IN THE DRAWING:

FIG. 5A

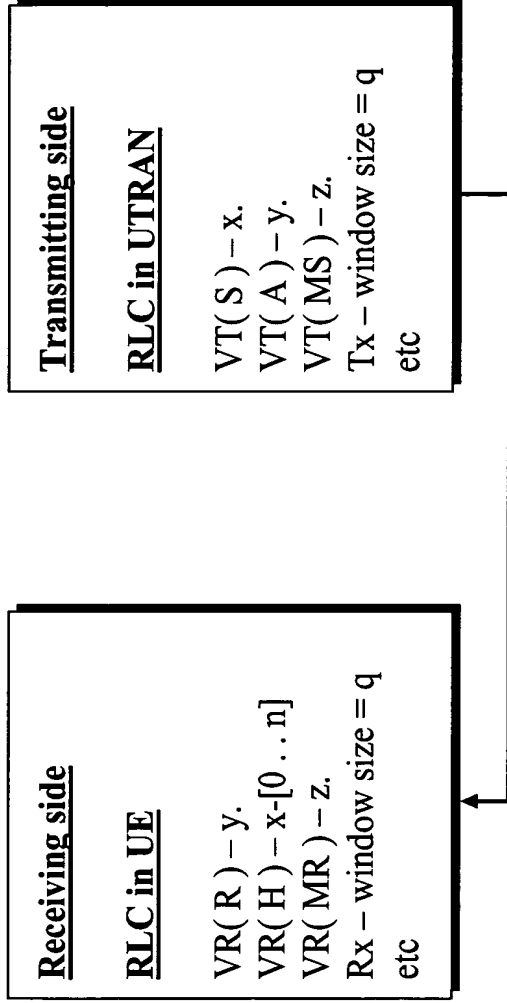
In Fig. 5A, please replace "VR(A)-y." with --VT(A)-y.-- on the transmitting side; and

In Fig. 5B, replace "VR(A)-0." With --VT(A)-0.-- in the transmitting side.

A marked-up copy of Figs. 5A and 5B is enclosed along with a replacement sheet. Approval is requested.
